**ADDENDUM TO THE CONTRACT
for the
CBJ Consolidated Public Works Facility
Streets Wing Addition
Contract No. E10-273**

ADDENDUM NO.: TWO

DATE ADDENDUM ISSUED: June 25, 2010

SHEET NO.
A1.03

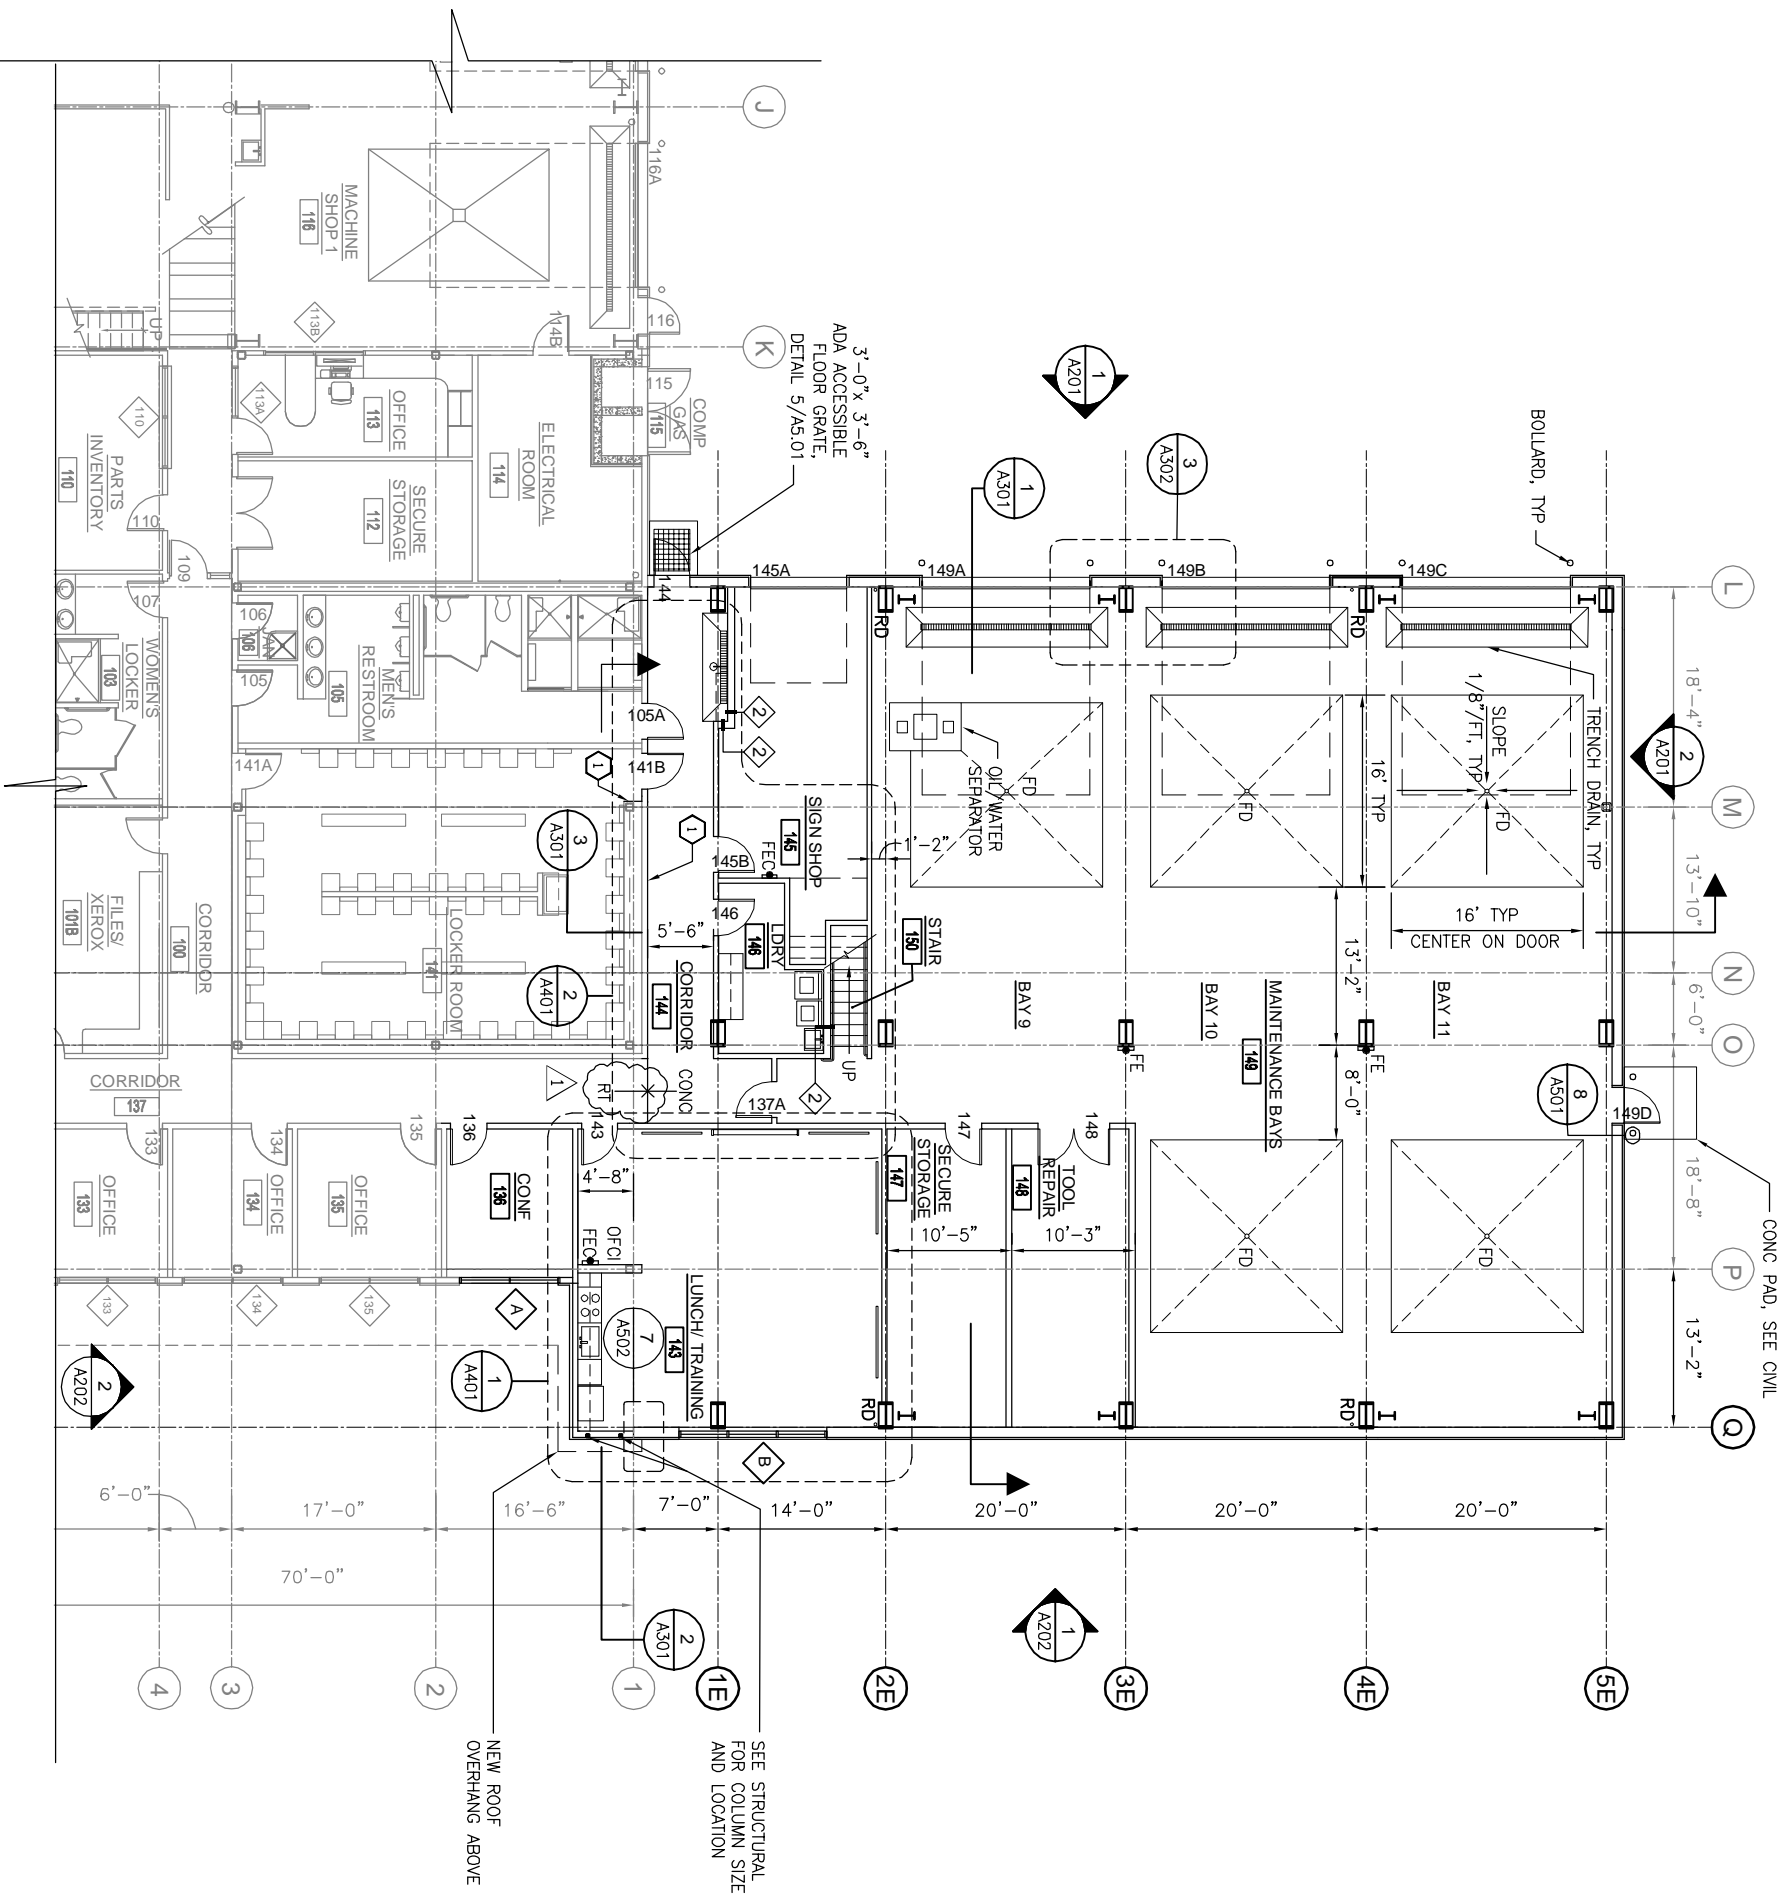
- Item No. 8 Sheet A1.03 – First Floor Plan. **Delete** in its entirety and **replace** with Sheet A1.03 labeled Addendum No. 2, located at http://www.juneau.org/engineering_ftp/contracts/Contracts.php - follow the link to this project and click on Addendum No. 2. (Change Floor Finish Material in Corridor 137 from VCT to RT)

ROOM FINISH SCHEDULE
AND WALL TYPES

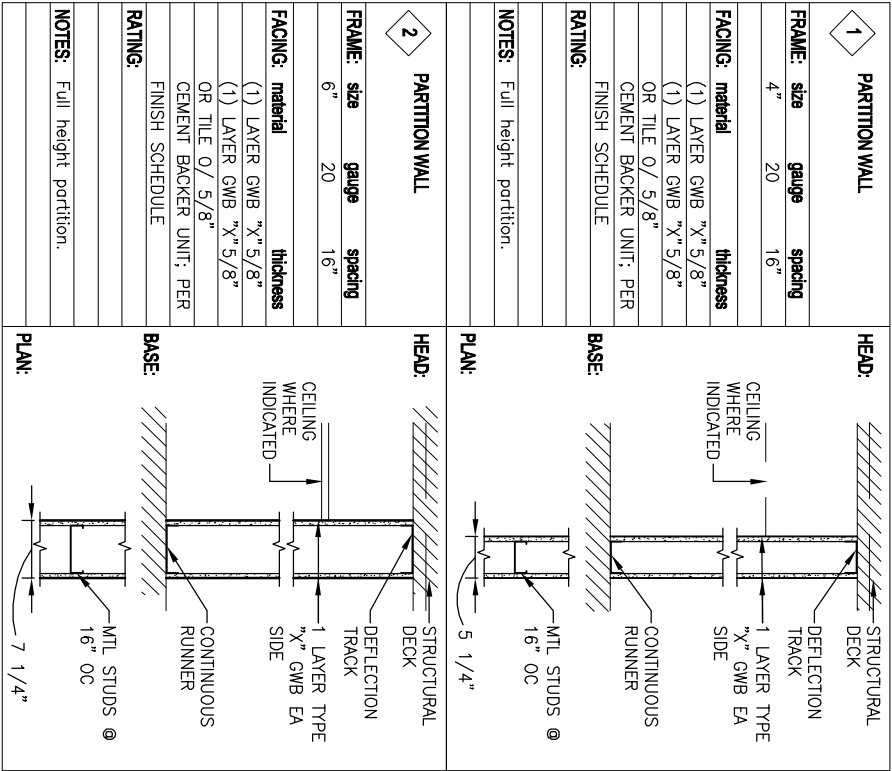
- Item No. 9 Sheet A6.01 – Room Finish Schedule and Wall Types. **Delete** in its entirety and **replace** with Sheet A6.01 labeled Addendum No. 2, located at http://www.juneau.org/engineering_ftp/contracts/Contracts.php - follow the link to this project and click on Addendum No. 2. (Change Floor Finish material in Corridor 137 from VCT to RT).
